**AMENDMENTS TO THE DRAWINGS:**

## **REMARKS**

FIG 2

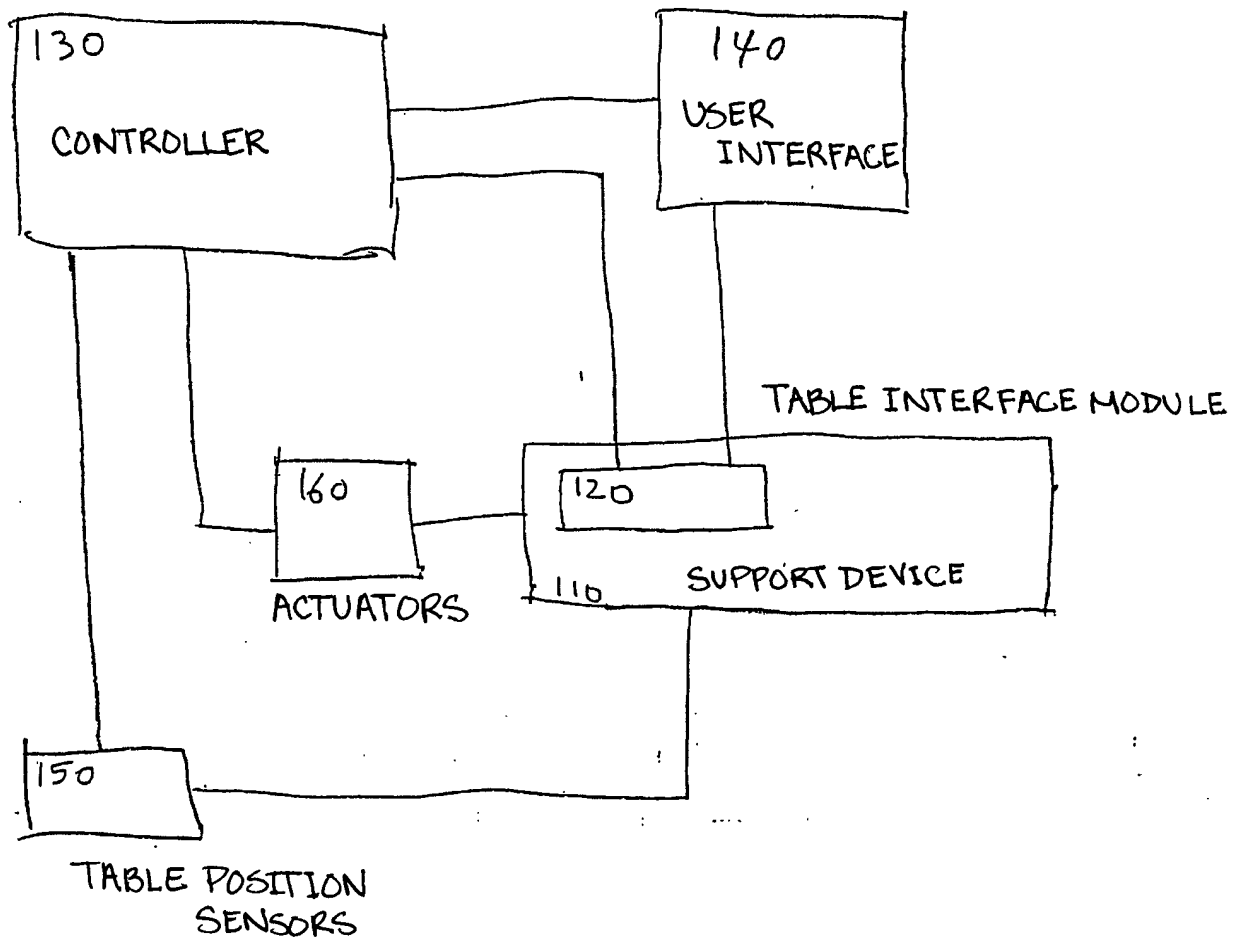
As a preliminary matter, in the Office Action mailed May 31, 2005, the Examiner has objected to the drawings “because ‘contents in a flowchart boxes of figure 2 are not shown.’” (See Office Action, 5/31/05, pg. 2). The applicants respectfully disagree with the Office Action’s characterization of Figure 2. Figure 2 illustrates a schematic block diagram of a patient positioning assembly for therapeutic radiation treatment, and not boxes of flowchart. Applicants have amended Figure 2 to more clearly indicate the reference numbers and labels of the contents of the block diagram of Figure 2. It is respectfully submitted that the proposed amendments to the drawings do not add new matter. Applicants respectfully request that the objection to the drawings be withdrawn.

The attached drawing sheets include a change to Figure 2. The sheet which includes Figure 2 replaces the original sheet including Figure 2. The figure has been amended to more clearly indicate the reference numbers and labels of the contents of the schematic block diagram of a patient positioning assembly for therapeutic radiation treatment in Figure 2. It is respectfully submitted that the proposed amendments to the drawings do not add new matter.
